S/D 97-9 - Final Plat of OXBOW 2ND ADDITION  
March 20, 1997 - Page 3

**S/D 97-9 FINAL PLAT OF THE OXBOW 2ND ADDITION**

**Response to Staff Comments**

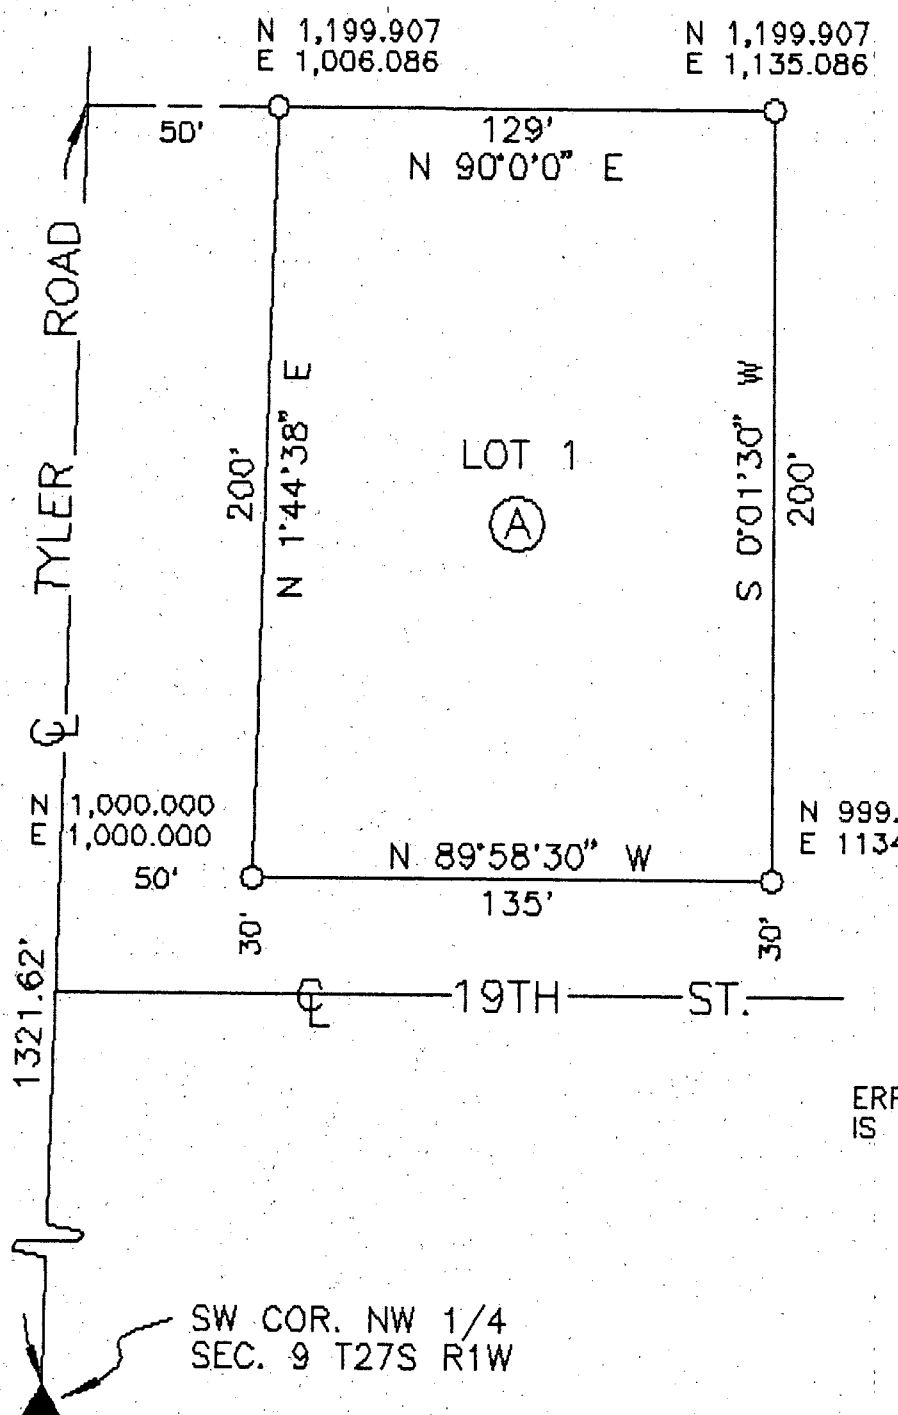
- D. On the final plat tracing, since this site is within Wichita's City limits, the plat's text shall note that the access controls are being dedicated to the "City of Wichita" and that the location of the opening to Tyler is to be approved by the City Engineer.

SKETCH PLAT  
REPLAT OF OX-BOW ADDITION  
LOT 1 BLOCK A  
1958 N TYLER

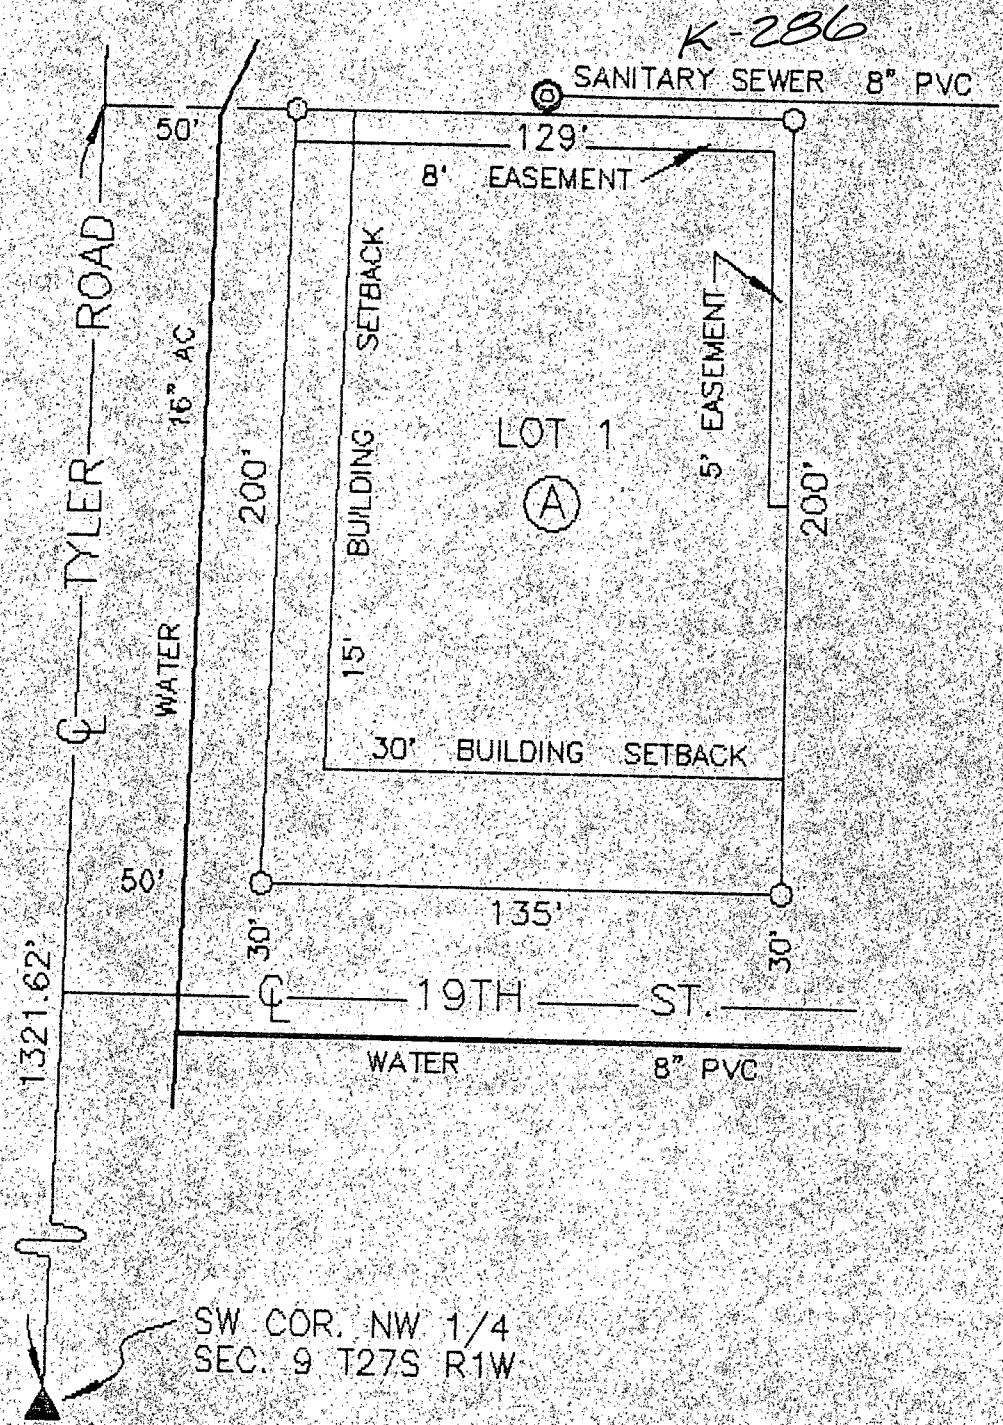
- C. As required by the zone change (Z-3195), the final plat tracing shall provide complete access control to 19th Street North. Also, access to Tyler Road shall be limited to one (1) opening. Both the face of the plat shall note such access controls and the plat's shall indicate the dedication of such access, further noting that the location of the opening to Tyler Road is subject to approval by the City Engineer.

- D. On the final plat tracing, the name of this Addition shall be changed to "Oxbow 2nd Addition". References in the plat's text, MAPC signatures, etc. shall also be changed accordingly. Referencing a "Replat" of an existing Addition is somewhat of an archaic practice. Also, present day records are based on the use of an individual name, rather than the referencing of a previous Addition.

- E. On the final plat tracing a 10-foot utility easement shall be provided along the north line of this site. As indicated by the sketch plat, the public 8-inch sanitary sewer line is located in this easement and present day standards require a 20-foot (10-foot of 1/2) easement.

- F. Rather than plat building setbacks, it is recommended that the final plat tracing exclude these setbacks, thereby allowing the setbacks to be determined by the zoning ordinance and the actual building orientation set for this site. If platted, the Subdivision Resolution will require for business zoning that a 35-foot building setback be shown to Tyler and a 20-foot building setback to 19th Street North. (Section 7-206 'D'). The "GO" zoning district requires a 20-foot front pad setback.

- A. Not applicable - Services are existing.
- B. Not applicable - Services are existing.
- C. See revised final plat for applicant's need of access.
- D. Acknowledged - Done on revised final plat.
- E. Acknowledged - Done on revised final plat.
- F. Acknowledged - Setbacks are not shown on revised final plat.
- G. Acknowledged - Will provide.
- H. Acknowledged - Done on revised final plat.
- I. Not applicable - Services are existing.
- J. Acknowledged - Done on revised final plat.
- K. Not applicable - Services are existing.
- L. Acknowledged - Will provide.
- M. Acknowledged - Will record plat within 30 days.
- N. Will provide easements required by utility companies.
- O. Will comply with requirements of City Engineering, however lot is already developed and no drainage problems exist.
